RE: Contract No. DACW43-00-D-0515, Task Order 0004
Transmittal of Revision C of the Methodology for Release of Railroad Ties from the
St. Louis FUSRAP Sites

Contractor: SAIC	Contract Number DACW43-00-D-0515	Document Date: August 2002
Revision 0	TECHNICAL WORK RECORD 01-010 METHODOLOGY FOR RELEASE OF RAILROAD TIES FROM THE ST. LOUIS FUSRAP SITES	
	Comments from D. McKinley Dated August 19, 2002

**SAIC
TECHNICAL WORK RECORD 01-010
METHODOLOGY FOR RELEASE OF RAILROAD TIES
FROM THE
ST. LOUIS FUSRAP SITES**

**REVISION C
ST. LOUIS, MISSOURI**

Figure 1. Survey Protocol for Release of Railroad Ties

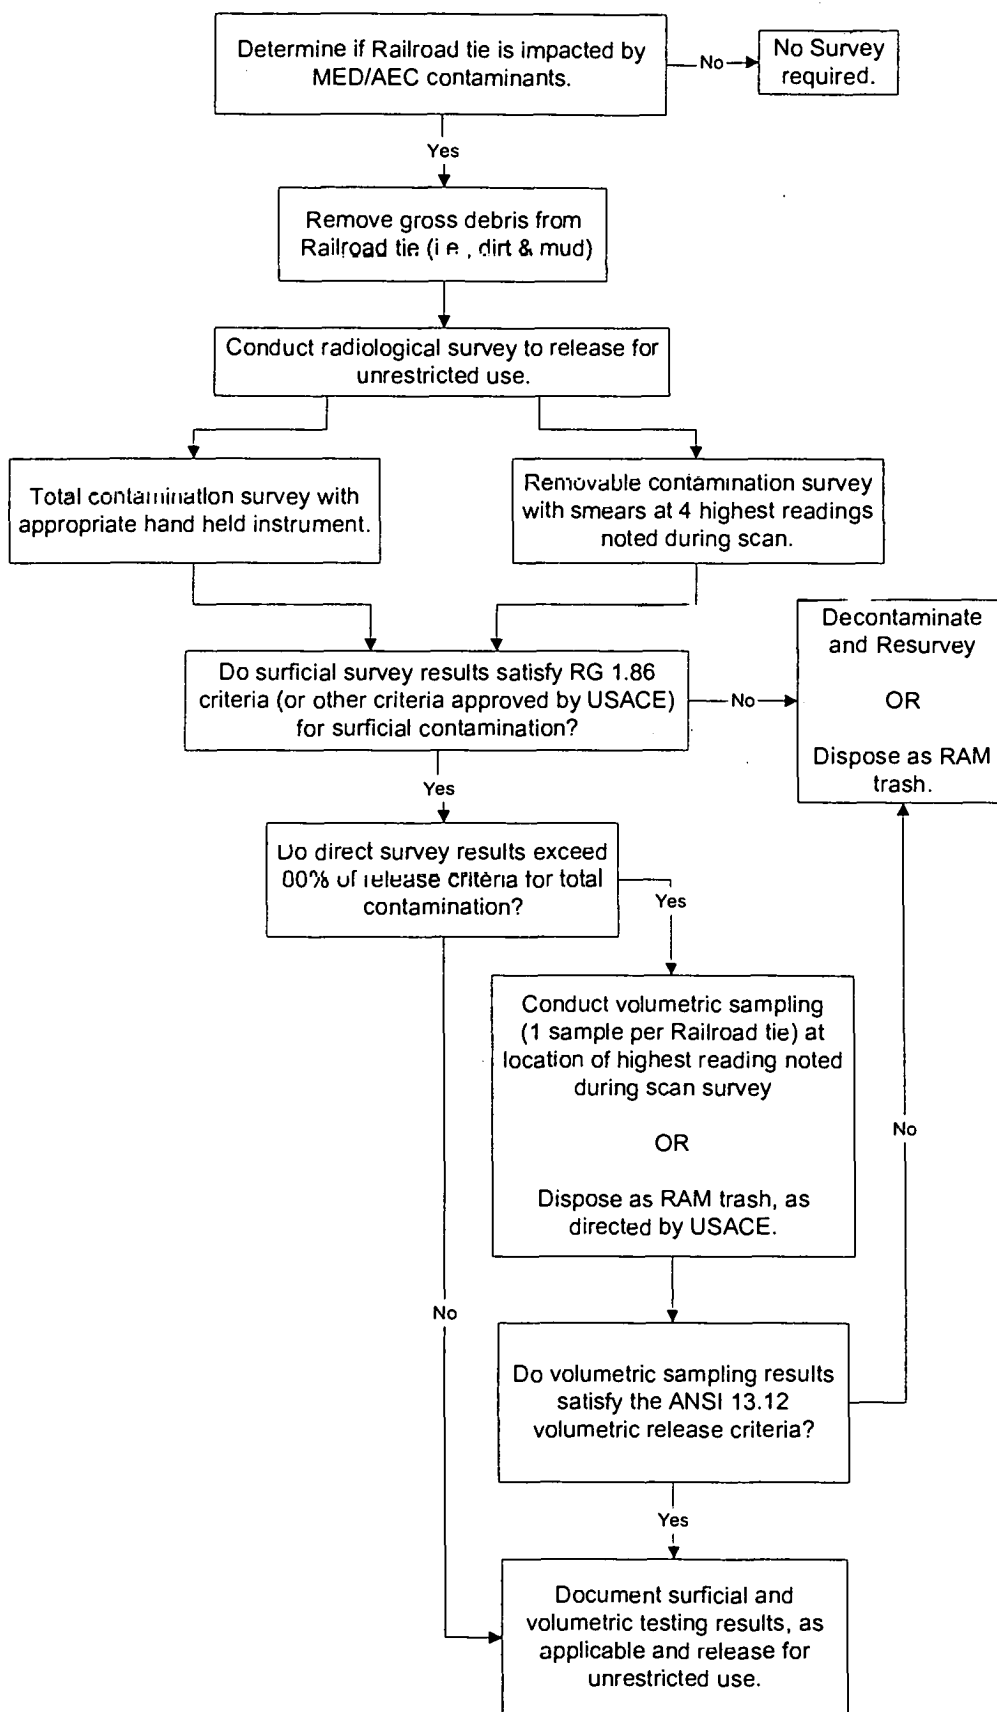
5	Figure 1	<p>Suggest the figure be footnoted and/or a discussion added to the text to present the criteria and decision logic to be utilized in the field to determine whether or not a tie is potentially impacted by MED/AEC contamination as opposed to other potential sources (e.g., at SLDS, potential CT contamination is a concern). Alternatively, suggest the text in the first box be rewritten as follows: "Determine if railroad tie is potentially impacted".</p>	<p>Agree that first box is too restrictive. The first box has been changed to read, "Is the RR tie located in an area for which USACE has determined remediation to be appropriate?"</p> <p>No – RR tie not impacted. No survey required for unrestricted release.</p> <p>Yes – Points to next box, "Remove gross debris from RR tie"</p>
6	P 3, ¶1	<p>First sentence. Please capitalize "Release".</p> <p>Last sentence. Suggest "this paper" be replaced with "this TWR".</p>	<p>Agree. Release has been capitalized.</p> <p>Agree. Text changed as suggested.</p>
